Technical Information

991 GT3 Cup

Installation additional retaining bracket for fire extinguisher

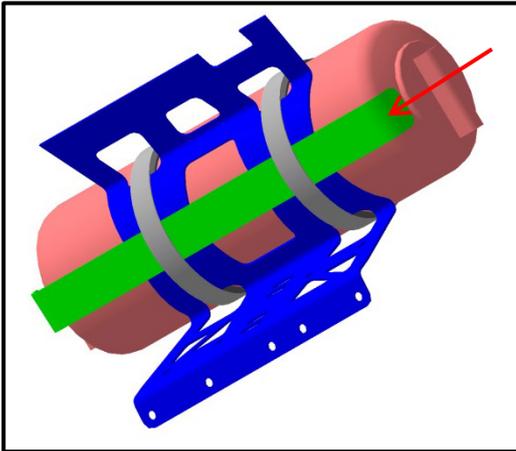
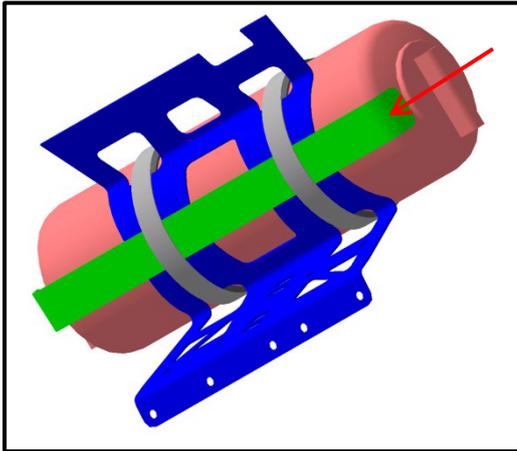
2. Schraubschellen am Feuerlöscher öffnen.

2. Loosen the fire extinguisher reservoir retaining clamps at the points indicated in the image below. Do NOT remove the fire extinguisher.

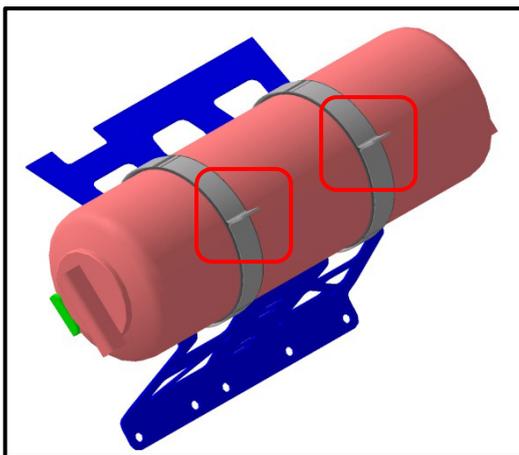
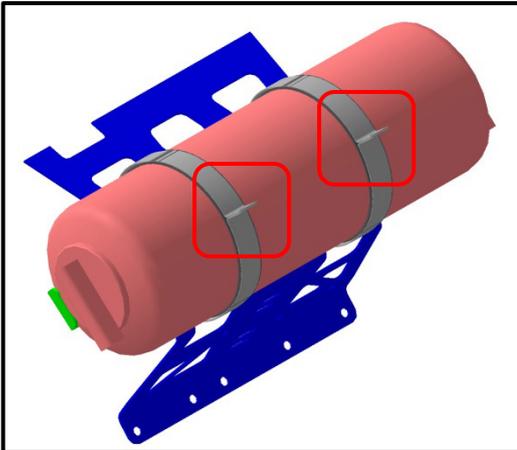
- Bei eingebautem Feuerlöscher den Zusatzhalter Feuerlöscher zwischen karosserieseitiger Aufnahme und Schraubschellen einführen.

3. With the fire extinguisher reservoir still in position insert the additional bracket between the retaining clamps and underside of the reservoir mounting bracket as shown in the image below.
